Re: 4824 Edgemoor Lane  
Sketch Plan No. 320200020 and Preliminary Plan No. 120200070

RE: Sketch Plan No. 320200020  
Preliminary Plan No. 120200070  
4824 Edgemoor Lane

**DATE:** 28-Jan-20  
**TO:** Stephen Crum - [scrum@mhgpa.com](mailto:scrum@mhgpa.com)  
Macris, Hendricks & Glascock  
**FROM:** Marie LaBaw  
**RE:** 4824 Edgemoor Lane  
120200070

Re: Stormwater Management **CONCEPT** Request  
for Edgemoor  
Preliminary Plan #: 120200070  
SM File #: 285454  
Tract Size/Zone: 0.18 Ac./CR-2  
Total Concept Area: 0.26 Ac.  
Lots/Block: P16/13  
Watershed: Little Falls Branch

Fire Department Access Review

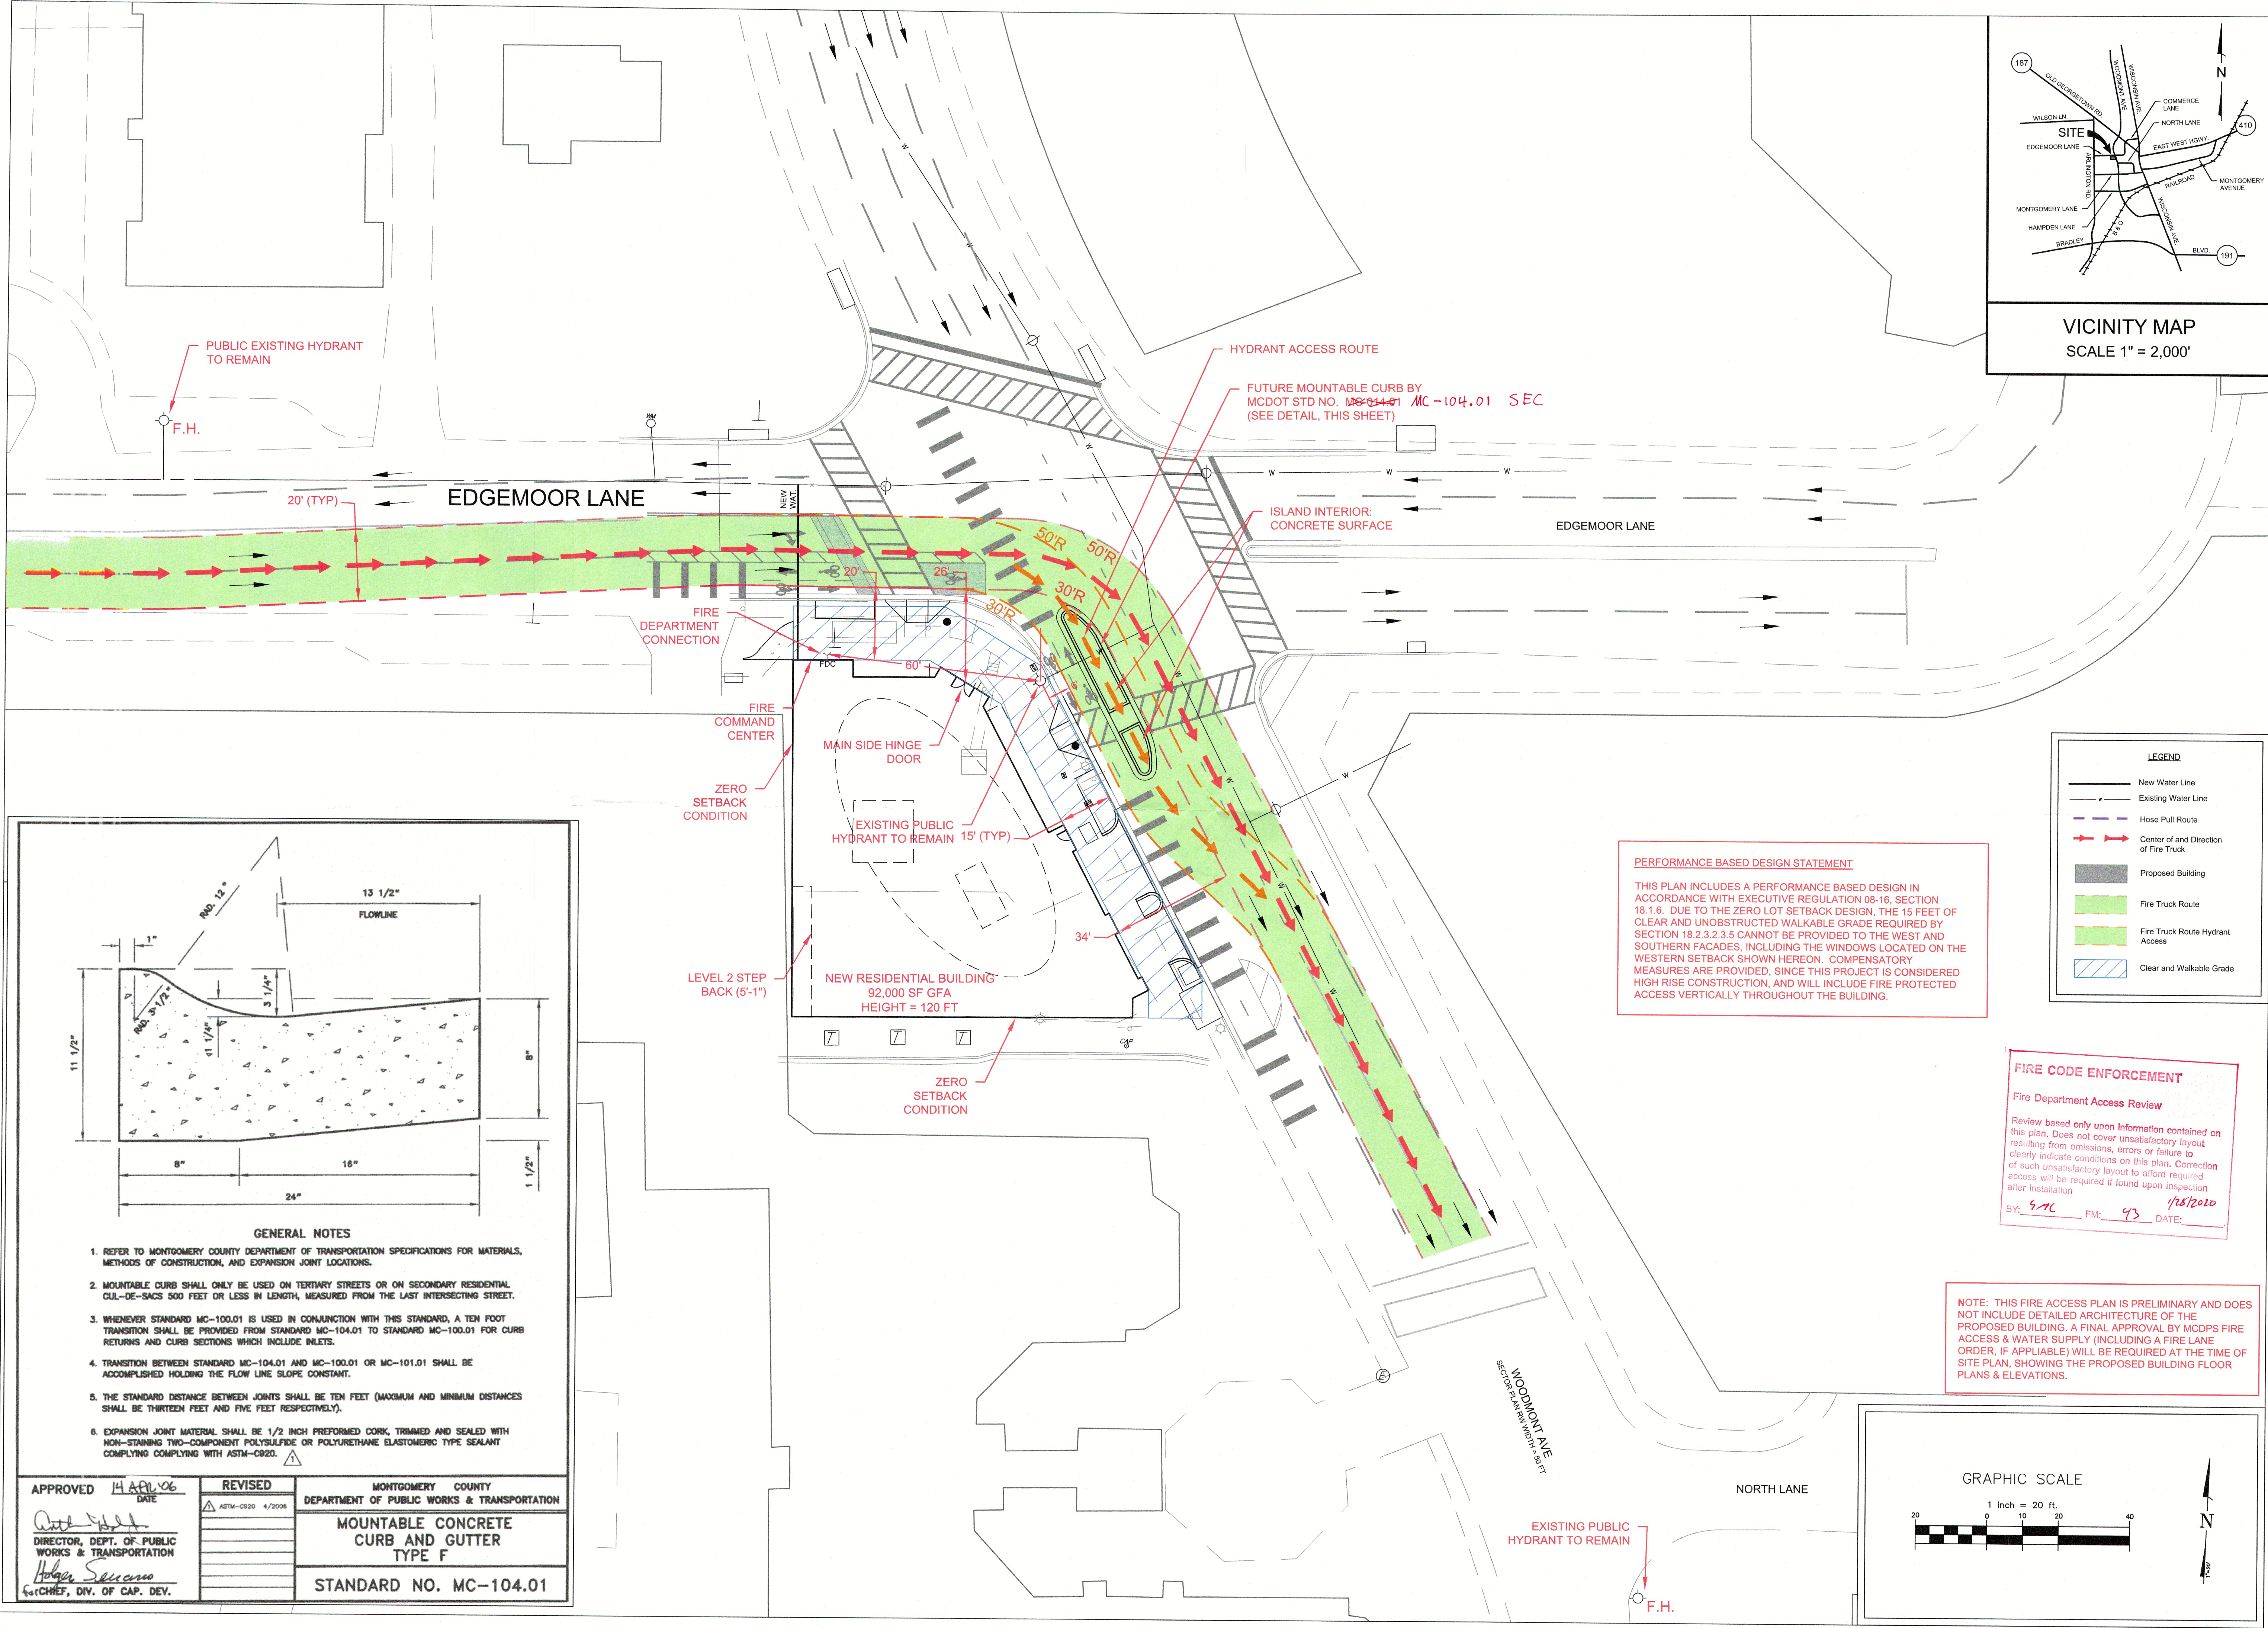
**\*\*\* See Statement of Performance Based Design; Zero lot line condition with highrise building protections \*\*\***

THIS PLAN INCLUDES A PERFORMANCE BASED DESIGN IN ACCORDANCE WITH EXECUTIVE REGULATION 08-16, SECTION 18.1.6. DUE TO THE ZERO LOT SETBACK DESIGN, THE 15 FEET OF CLEAR AND UNOBSTRUCTED WALKABLE GRADE REQUIRED BY SECTION 18.2.3.2.3.5 CANNOT BE PROVIDED TO THE WEST AND SOUTHERN FACADES, INCLUDING THE WINDOWS LOCATED ON THE WESTERN SETBACK SHOWN HEREON. COMPENSATORY MEASURES ARE PROVIDED, SINCE THIS PROJECT IS CONSIDERED HIGH RISE CONSTRUCTION, AND WILL INCLUDE FIRE PROTECTED ACCESS VERTICALLY THROUGHOUT THE BUILDING.
